Triumph Service Bulletin

Amal Concentric Carb's

Number: (General) 2/73
Subject: Adjusting Float Level
Date: 7/18/73

CHECKING AND ADJUSTING THE AMAL CONCENTRIC FLOAT LEVEL

FIG. 1

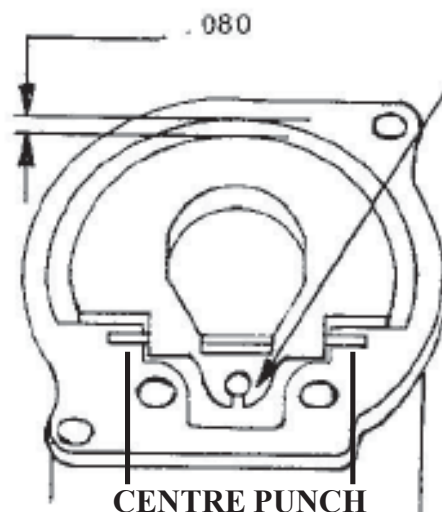
Remove the float assembly from carburetor. Drain gas from float bowl. Using a small screwdriver or other suitable tool, depress the float tab which operates the float needle, until needle contacts seat. While holding the float in this position, measure the distance from the top of float bowl to the top of float. The proper measurement is .080. If the measurement is less than .080 the float level will need lowering. SEE FIG. 1.

After checking, and if necessary, adjusting, float level to ensure it is exactly .080" below the bowl gasket surface, the staff at British Cycle Supply has found that gently staking the float pivot pin in position with a centerpunch in two spots, as noted in figure 1, is very important. This stops the float pivot pin from moving at all in the bowl, but still allows the float to pivot on the pin, thus maintaining the float setting and preventing the needle from cocking and sticking. We recommend performing all the work noted in this service bulletin on all Concentrics, even new ones. Be very careful, to avoid damaging seat or bowl.

FIG. 2

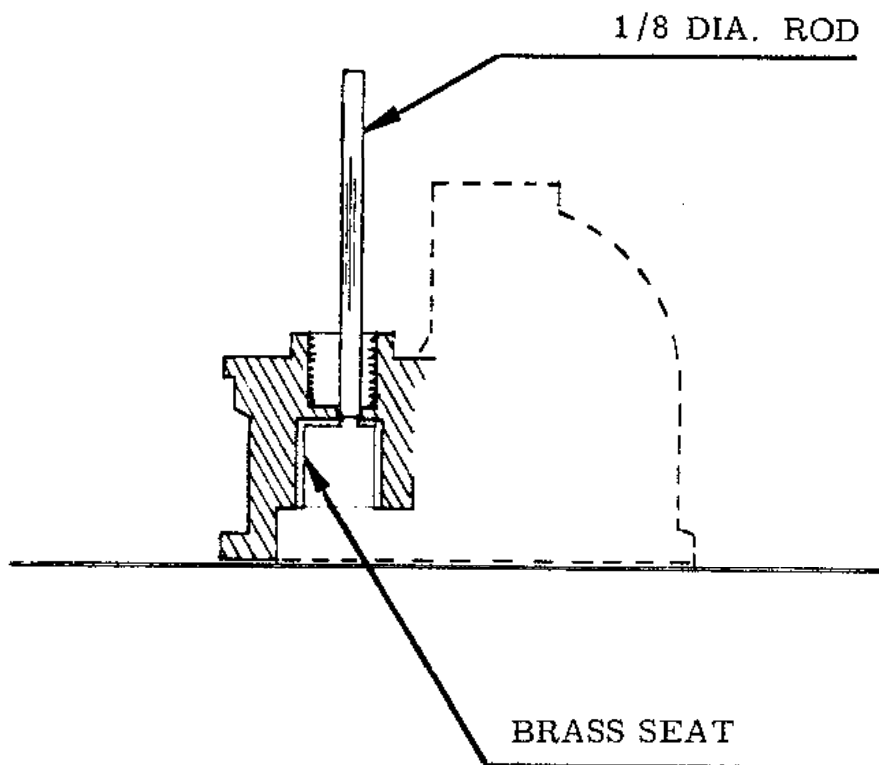
Remove all fittings from float bowl.

Using a propane torch, heat the bowl slightly. This will free the brass seat so it can easily be moved.

Using an 1/8 diameter rod, gently tap the brass seat until the proper setting is attained. SEE FIG. 2.

CAUTION: Do not attempt to move seat without heating bowl.
